Columbia County Building Permit

Columbia County Building Permit Application

From: The Columbia County Building & Zoning Department
Plan Review
135 NE Hernando Av.
P.O. Box 1529
Lake City Florida 32056-1529

On the date of October 12, 2006 application 0610-37 and plans for construction of a single family dwelling were reviewed and the following information or alteration to the plans will be required to continue processing this application. If you should have any question please contact the above address, or contact phone number (386) 758-1163 or fax any information to (386) 754-7088.

PNRS # 0610-37 AND 38

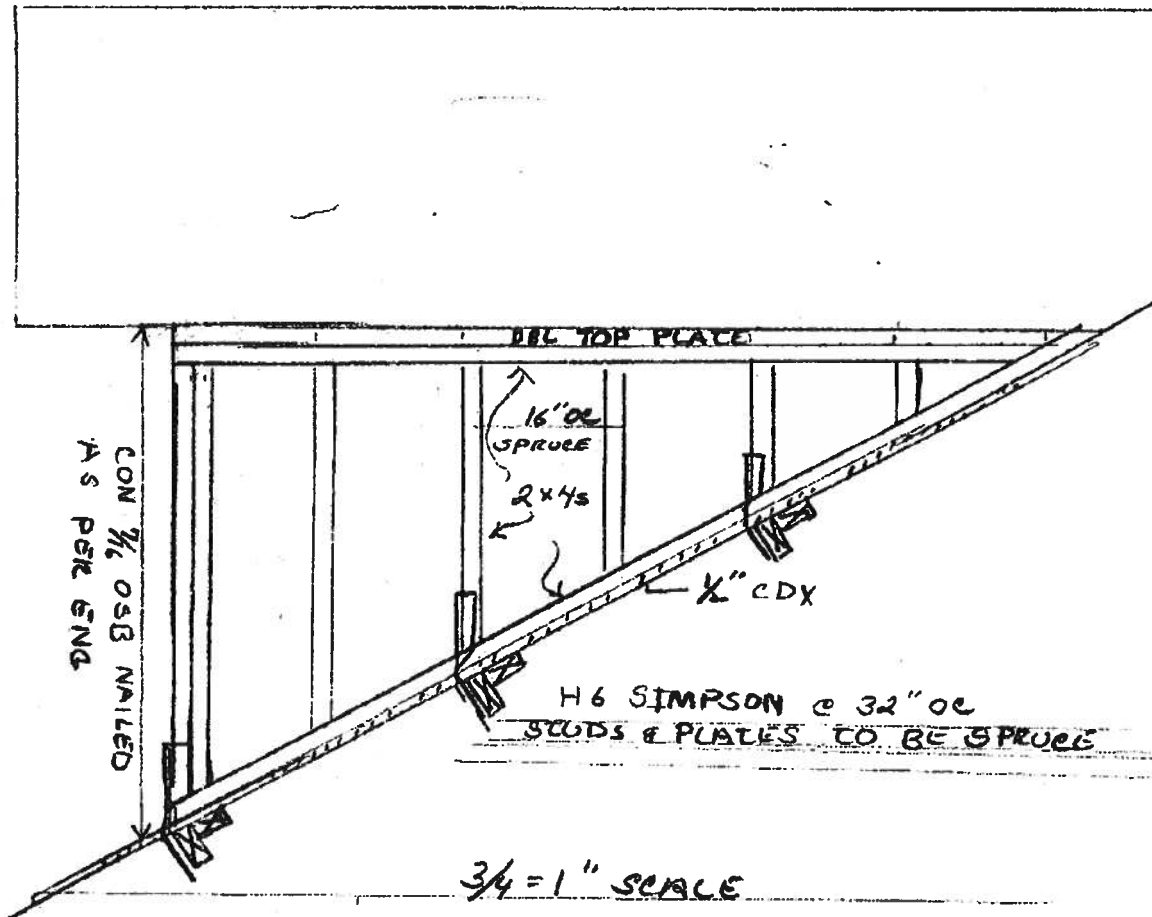
2. On the exterior load bearing walls which have opening for door, windows or headers which support roof trusses, show the headers size for each span and the required number of supporting members (jack and king studs) needed to support these headers.

ALL OF THE 36" OPENINGS SHALL HAVE 1 JACK AND 2 KING STUDS ON EITHER SIDE OF THE OPENINGS. THE FRONT DOOR, REAR FRENCH DOORS AND THE 30" WINDOW SHALL HAVE 2 KING & 2 JACKS ON EITHER SIDE OF THE OPENING. ALL HEADERS SHALL BE 2x12 YELLOW PINE. JACK AND STUD SHALL BE SPRUCE. GARAGE DOOR SHALL BE ENDED BEAM SUPPORTED BY 4 2x4x7' SPRUCE 2x4'S ON EACH END. EACH JACK SHALL BE ANCHORED AT THE BOTTOM WITH AN SPH 4 AND A STR 4 FOR JACK TO HEADER CONNECTION.

0610-38
 McALHANY GARAGE
 ROSENBOOM CON.

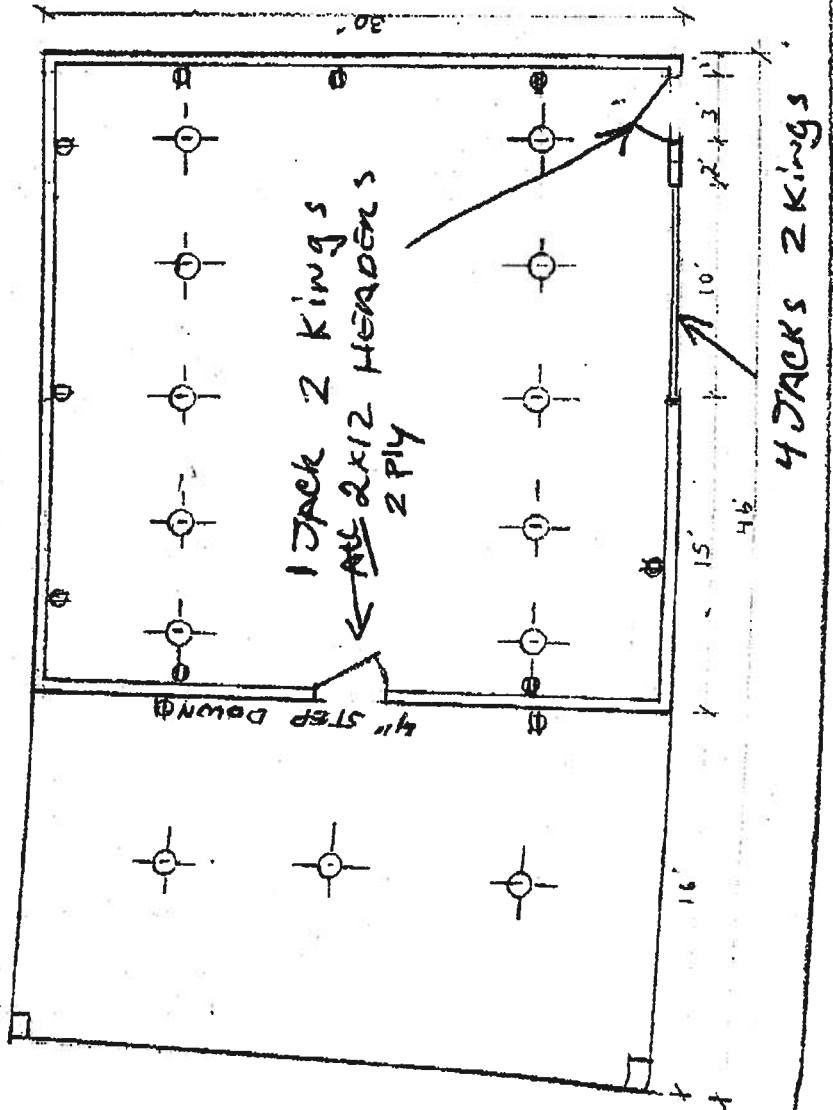
G. The garage has a sixteen foot opening for an overhead garage door; show a structural design which will detail the header beam size and the

Include in this design a detail showing the attachment of the beam and supporting members to the foundation.
